GM Apparels Ltd.

22nd November 2021

Observations

Lateral stability system

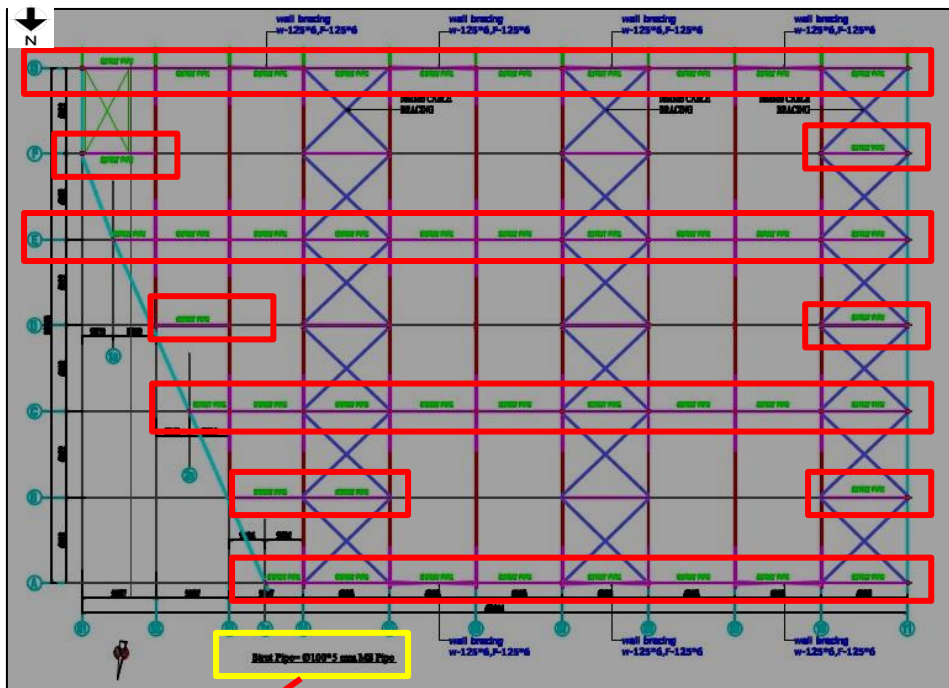
Strut Pipe was found missing at Marked location.

Strut pipe- 100 mm diameter and thickness 5 mm mentioned in the drawing

Strut bracing missing

Strut pipe was not found at site as per drawing

Lateral load transfer media (compression strut) along the ridge, eave and other positions are missing that have been shown in as-built drawing. Building engineer to check the lateral load path and review the stability of the structure accordingly.

Foundation adequacy check table

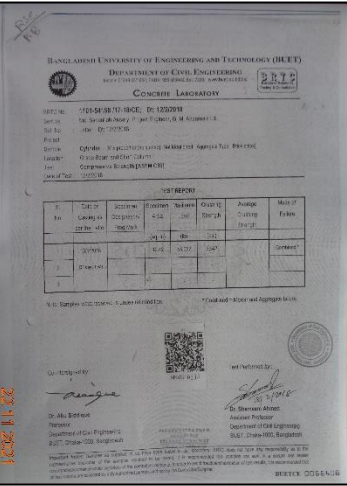
In design report, the foundation adequacy check table (marked location) shows that the provided footing area is less than the required footing area; which indicate that the footing area is inadequate. Also, no sample calculation was provided to represent the considerations.

As per BNBC, every building or structure designed shall have its design documents prepared in accordance with the provision of Section 1.9.1. The design document shall include a design report, and a set of structural drawings, which shall be prepared in compliance with section 1.9.1.1 and section 1.9.1.2 as per BNBC.

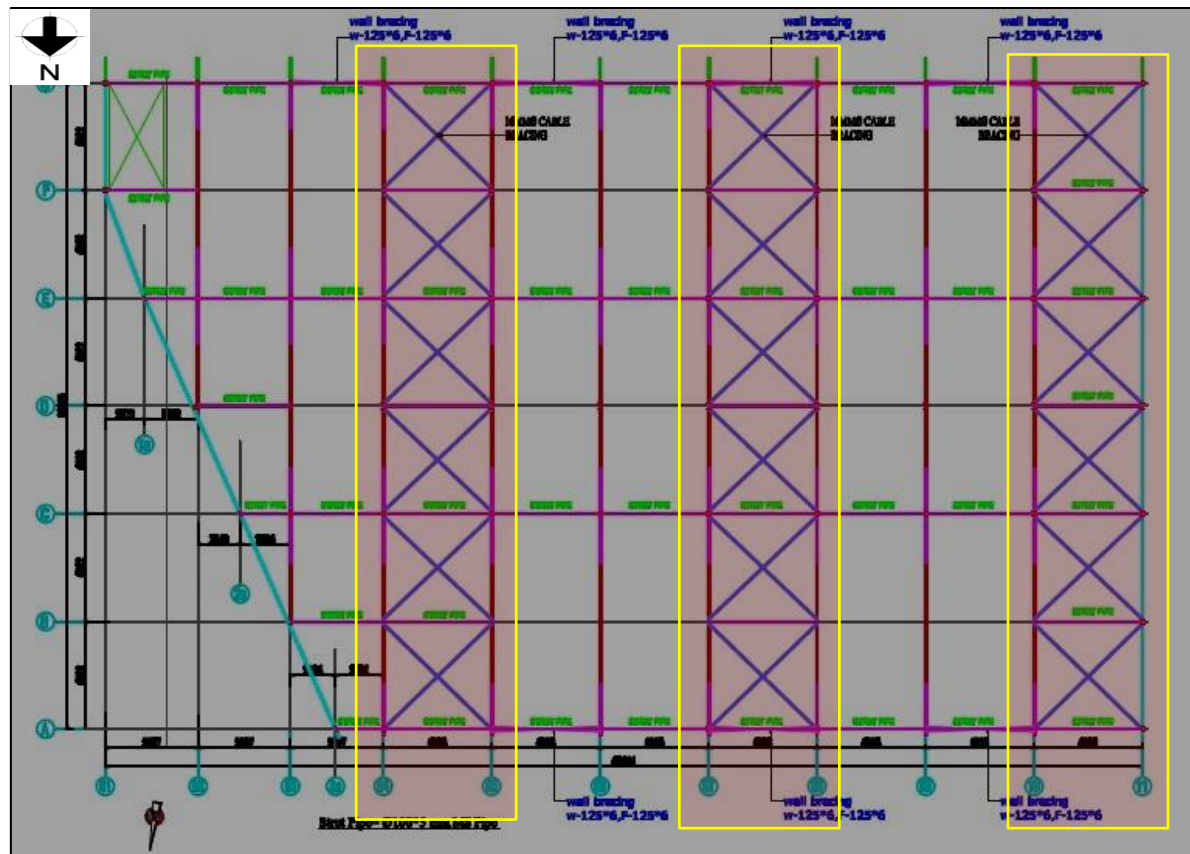
NOTE :
CONCRETE STRENGTH, $f'_c = 3,000$ Psi
CONCRETE MIX = 1:1.5:3 (With Brick Chips)
STEEL (f_y) = 6,0000 psi (60 grade)

Concrete strength has been considered 20.7 MPa but only one set of cylinder test report was available. Factory engineer is required to verify in-situ concrete and rebar strength and revise the design report accordingly.

Factory engineer is required to revise the design documents including material strength, floor loading and foundation capacity as per BNBC requirements.

Roof Bracing Layout plan

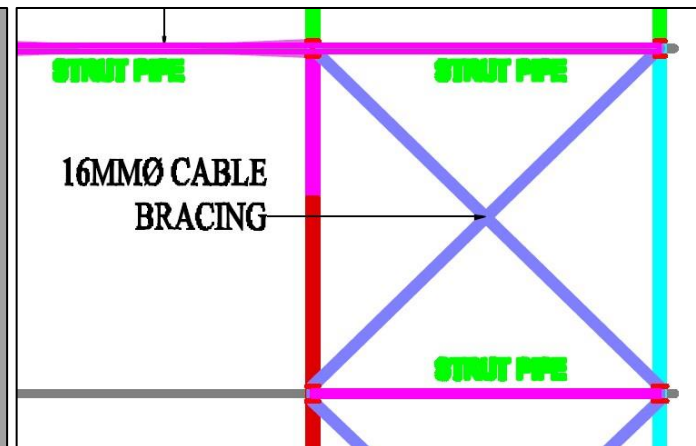
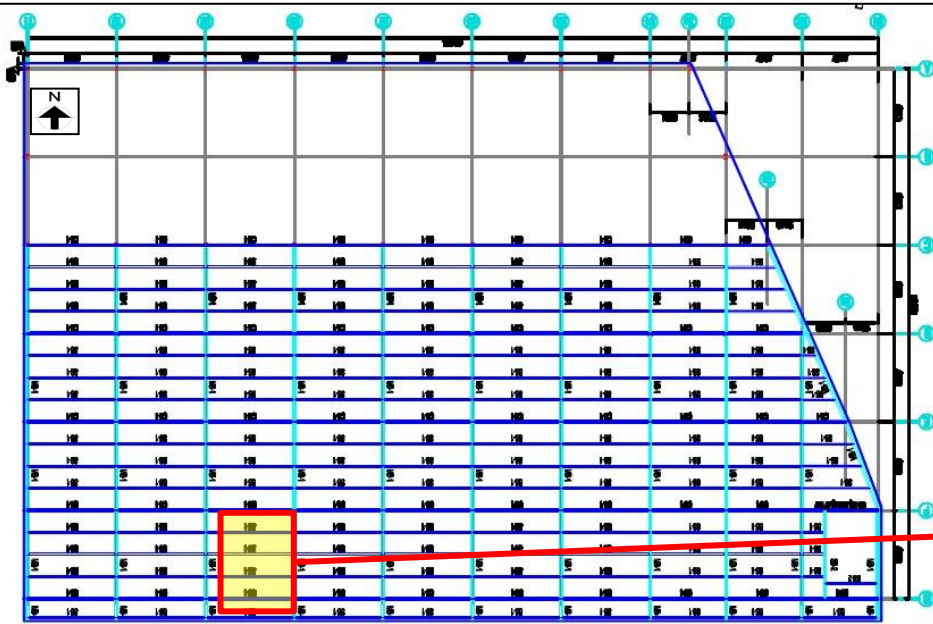
Cable Bracing of diameter 16 mm

Diameter of cable bracing was found 14 mm at site

In as-built drawing diameter of cable bracing has been shown in 16mm. But at site condition, the bracing diameter was found as 14 mm diameter.

Factory engineer is required to survey the whole structure and develop accurate as-built drawing.

1st floor beam Layout plan

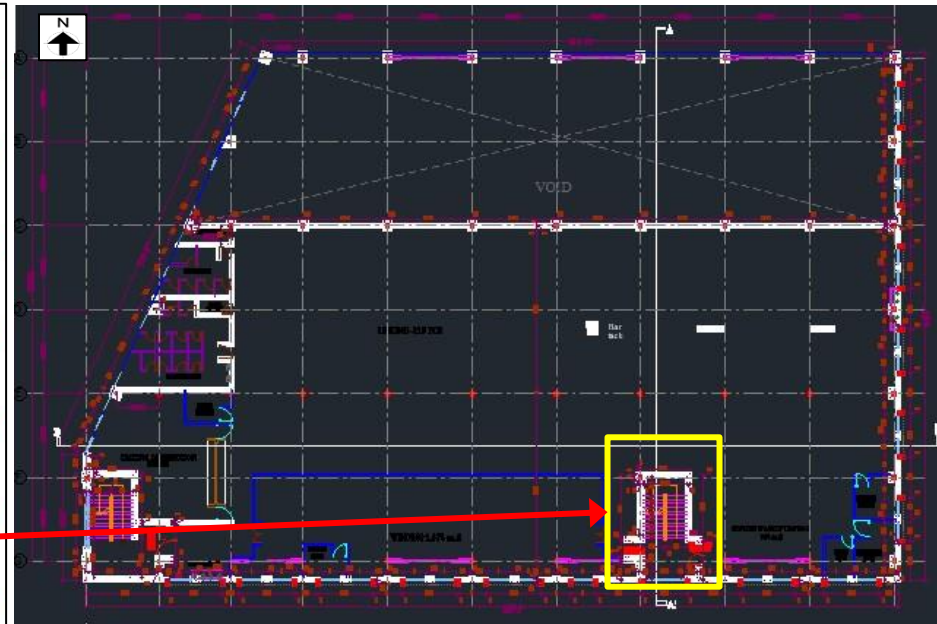
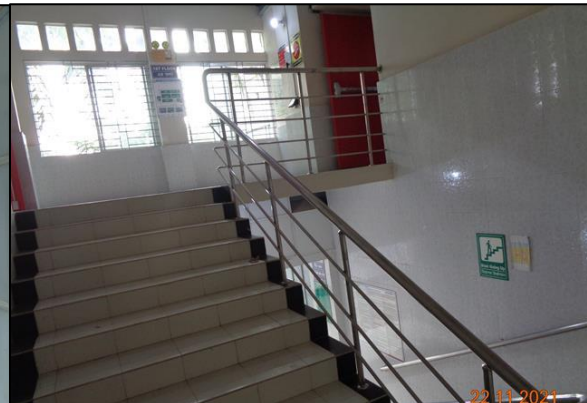
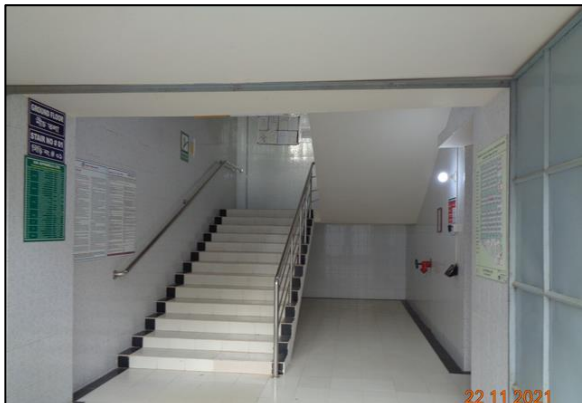
Stair was found at marked location

In as-built drawing of 1st floor beam layout plan (marked location), beam and sub-beam has been shown. But in floor layout plan and actual site condition, stair was found at the marked location. Factory engineer is required to survey the whole structure and develop accurate as-built drawing.

Connection gap at several locations

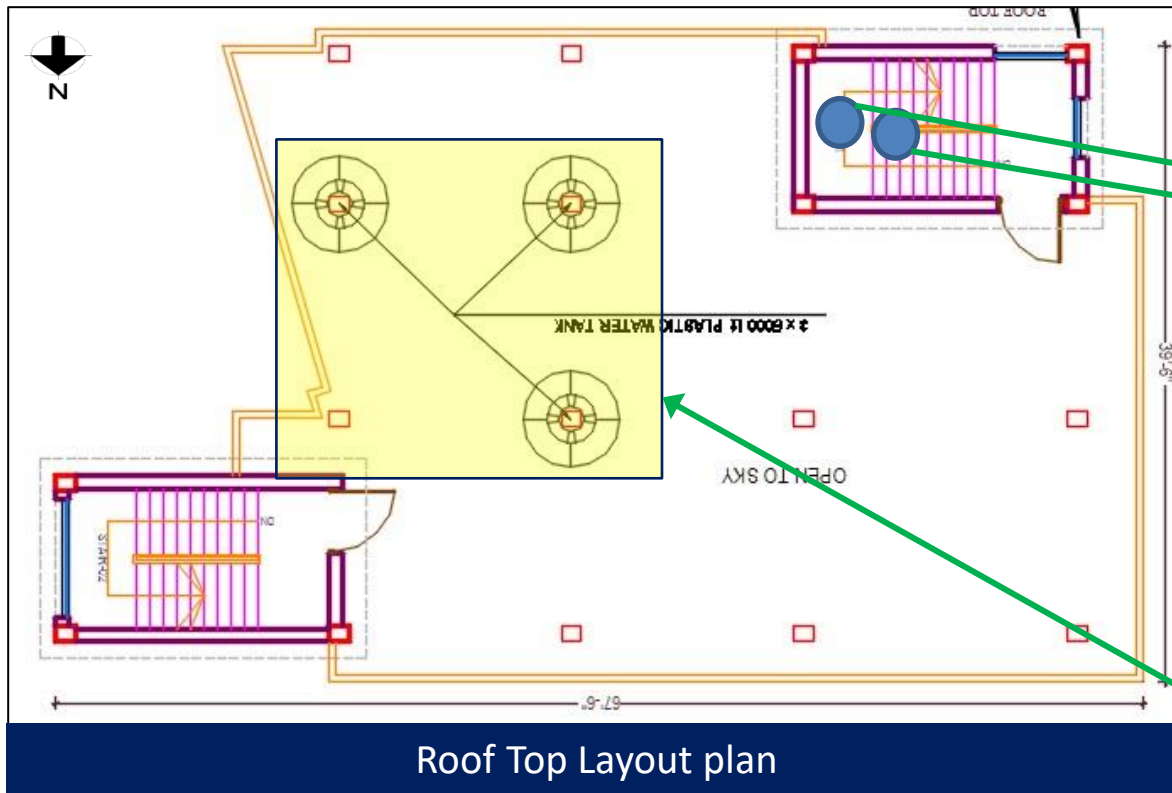
Rafter – Rafter connection

Vertical bracing connection

Significant gaps was found several location of the structure. Factory engineer is required to identify the location and carry out suitable remedial works.
